AFFORDABLE HOUSING
DEVELOPMENT SSD-83256463
ARCHITECTURAL DRAWINGS
THE BOULEVARDE
PUNCHBOWL
COLLINS AND TURNER
SEPTEMBER 2025

No	Date	By	Note
B	9/12/2025	DC	For RTS

Project	
Affordable Housing Development SSD-83256463 150 The Boulevard and 34 Dudley Street Punchbowl, NSW

Drawing Title Sightline Analysis

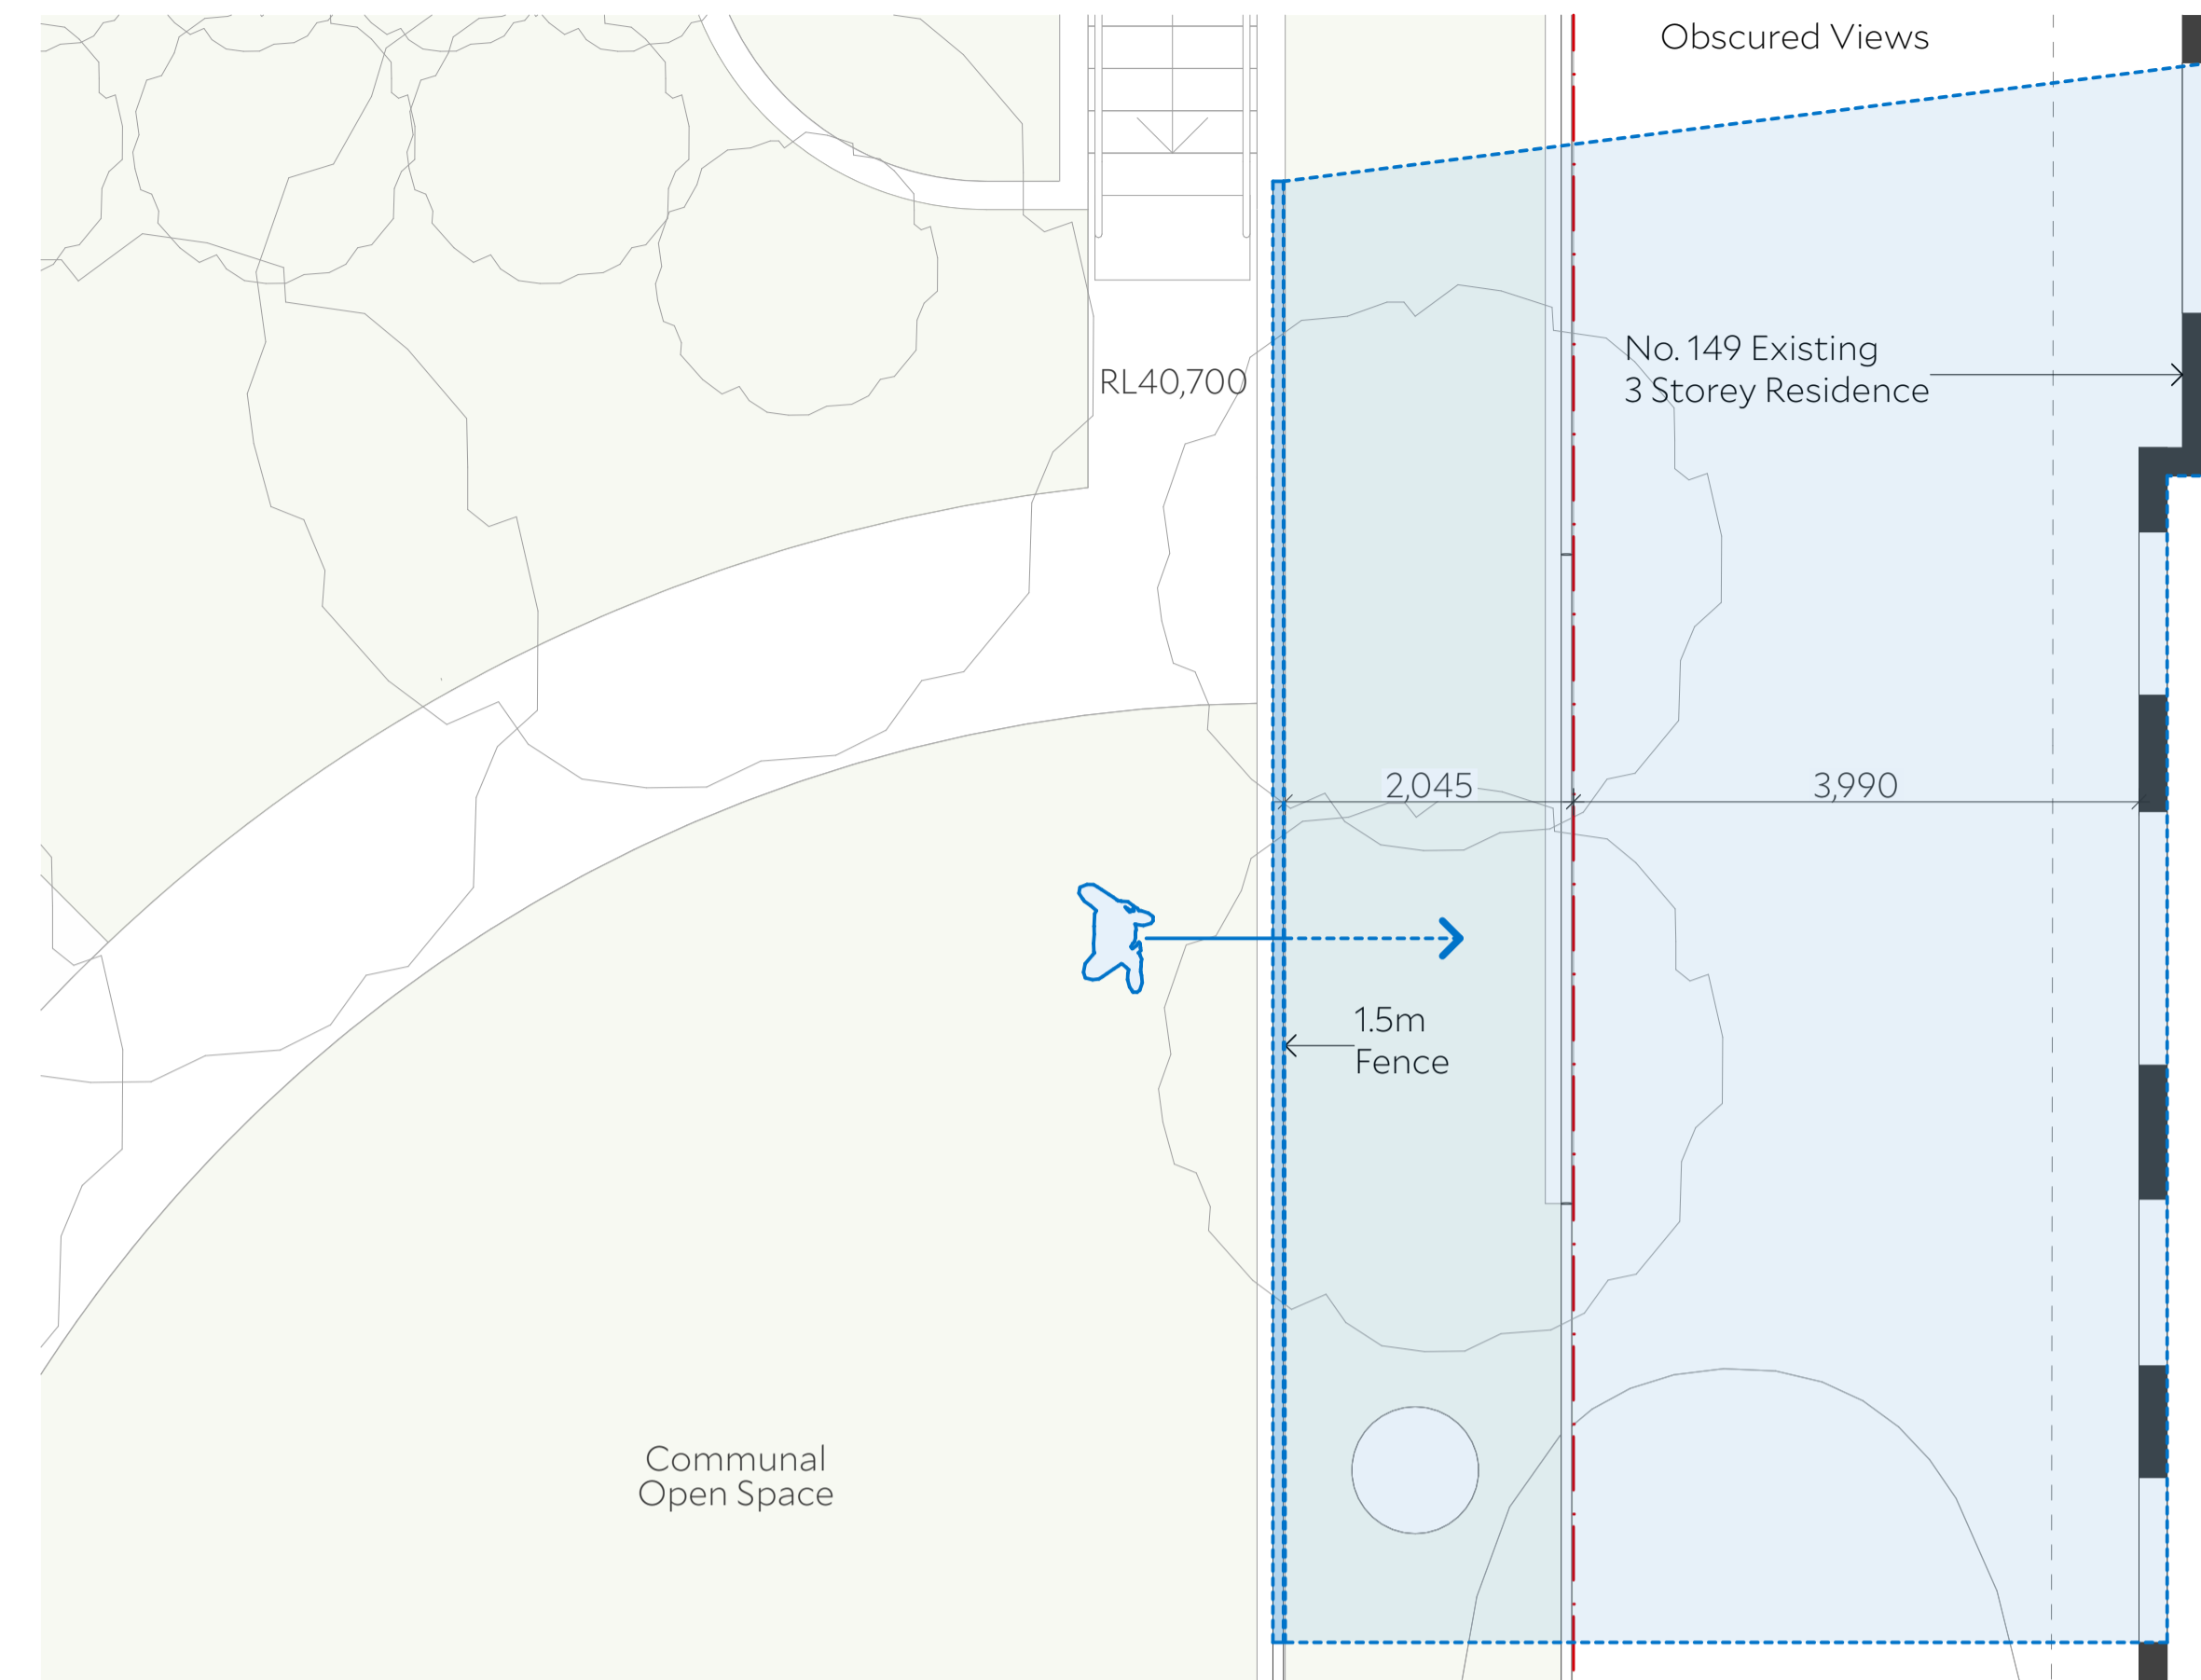
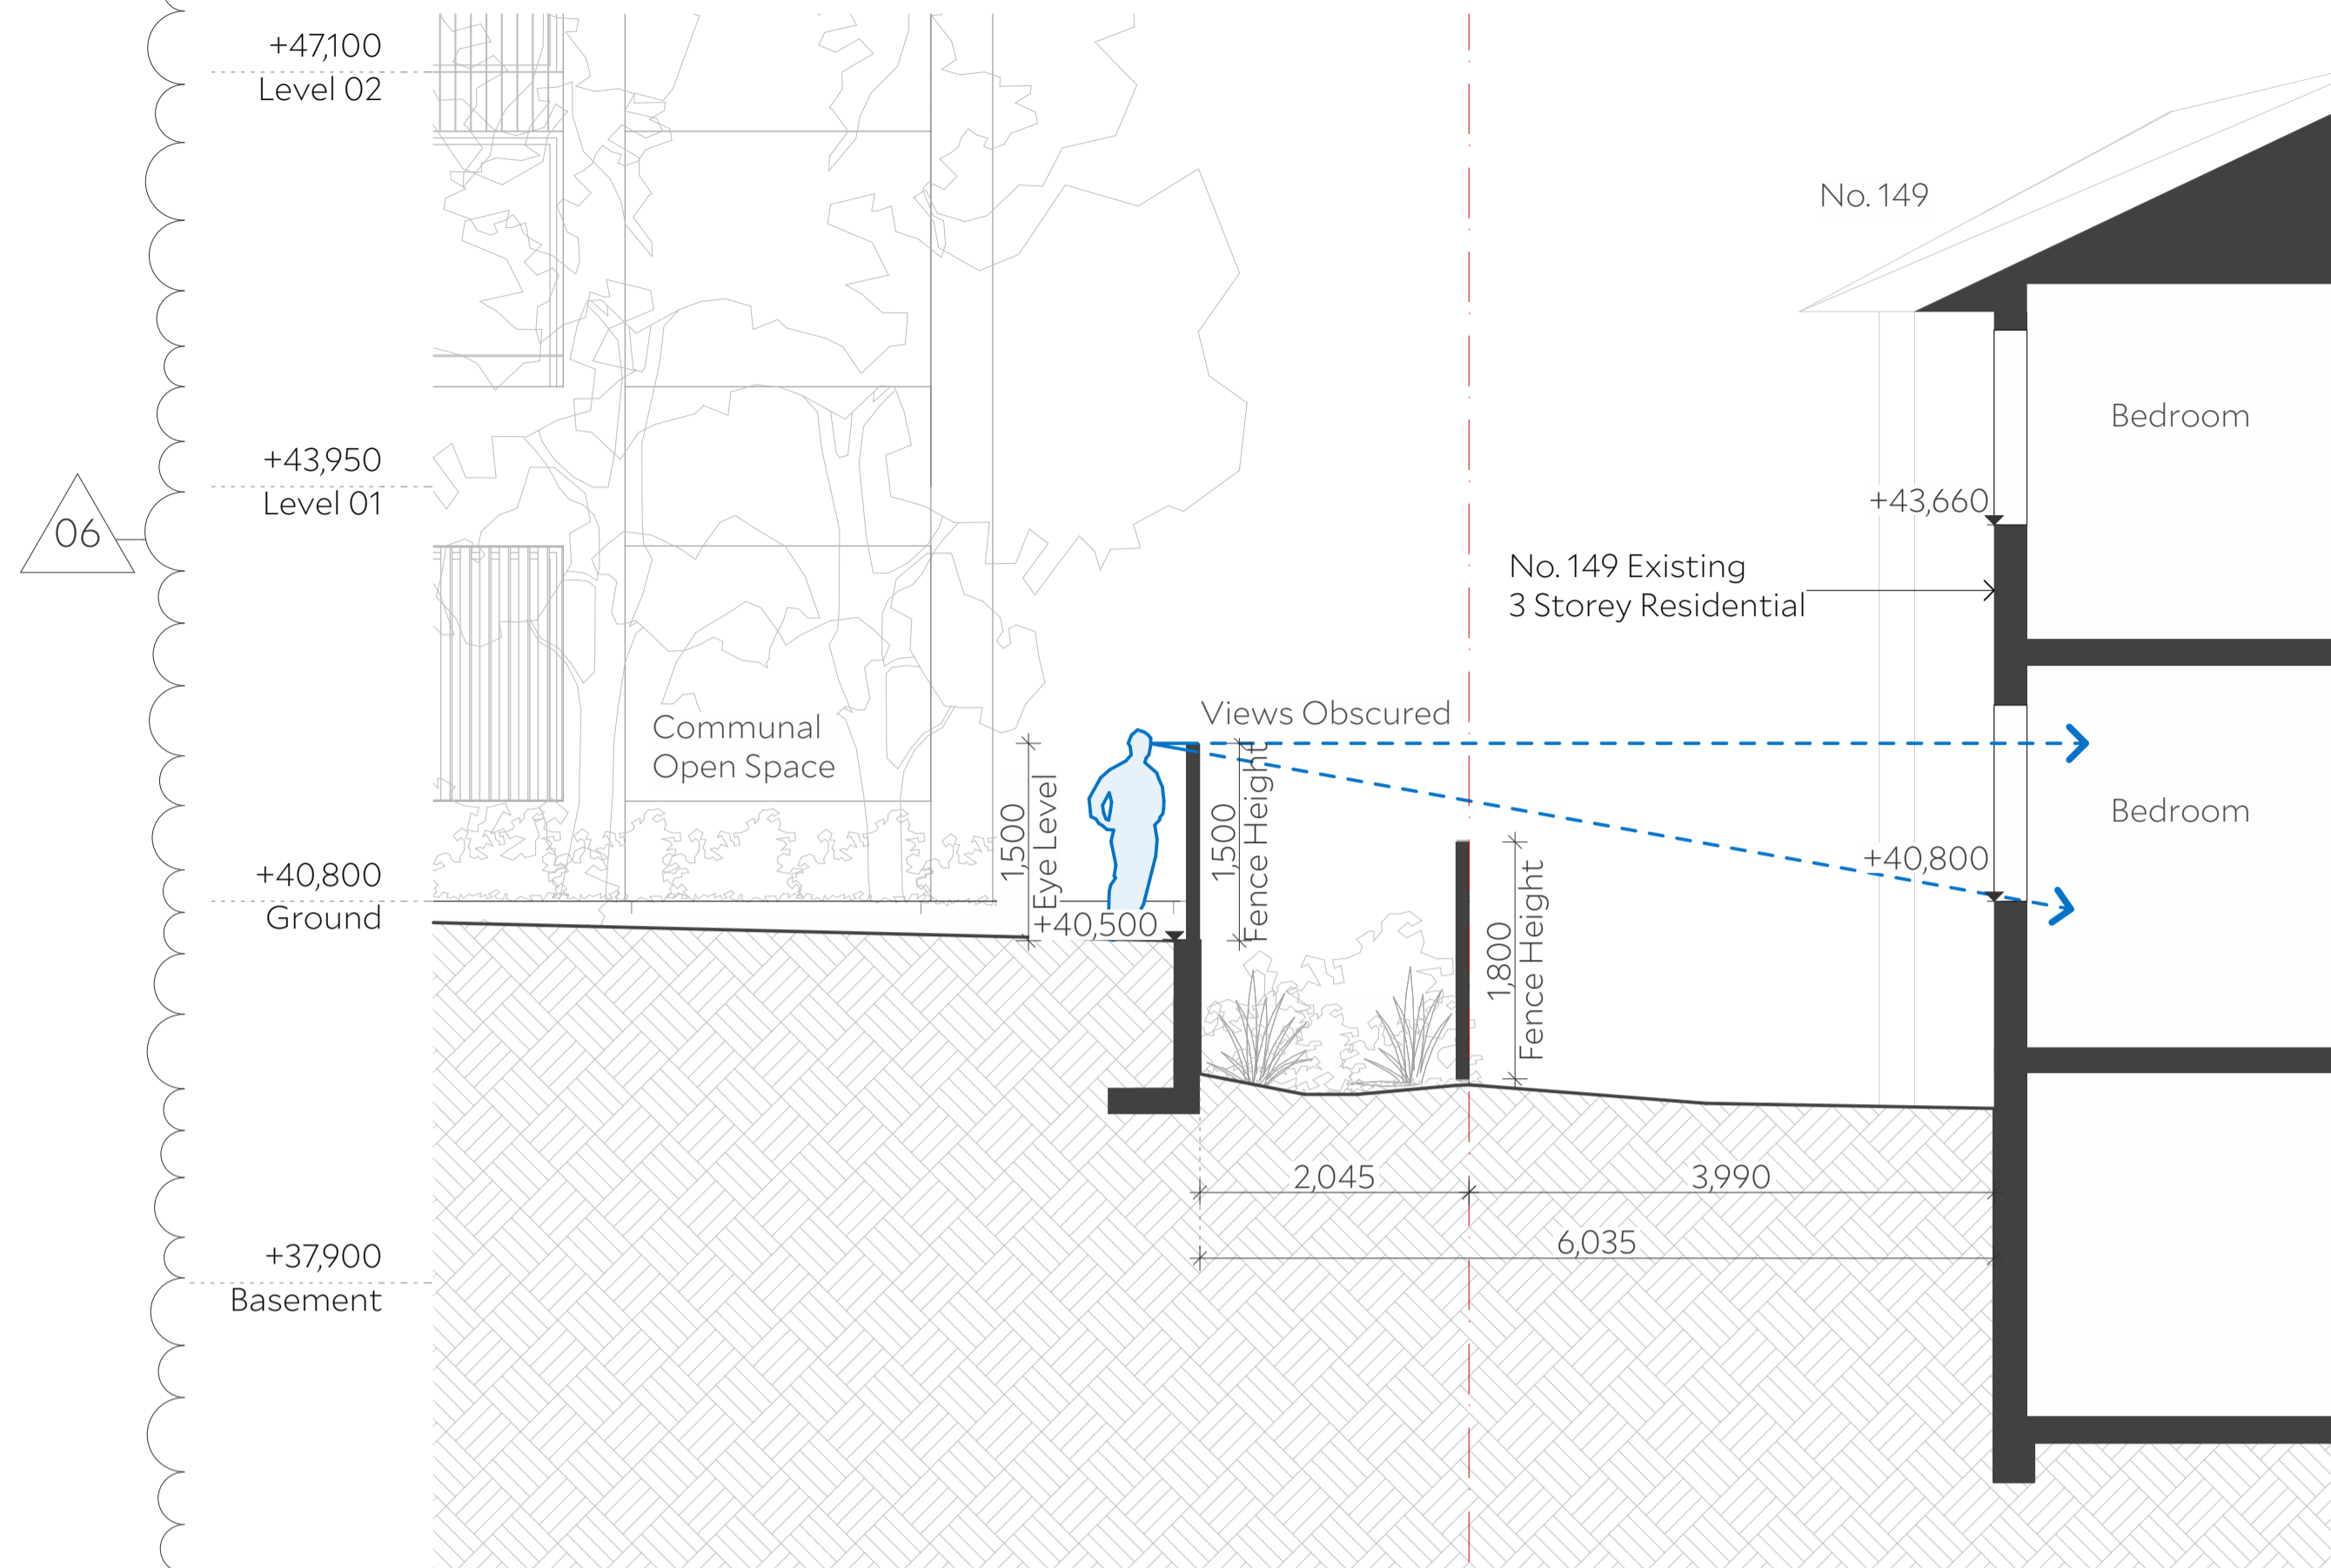
ID	Name
05	Privacy screens added and pathway repositioned Refer to RTS Item DPHI 7
06	Landscape privacy screen added Refer to RTS Item DPHI 8
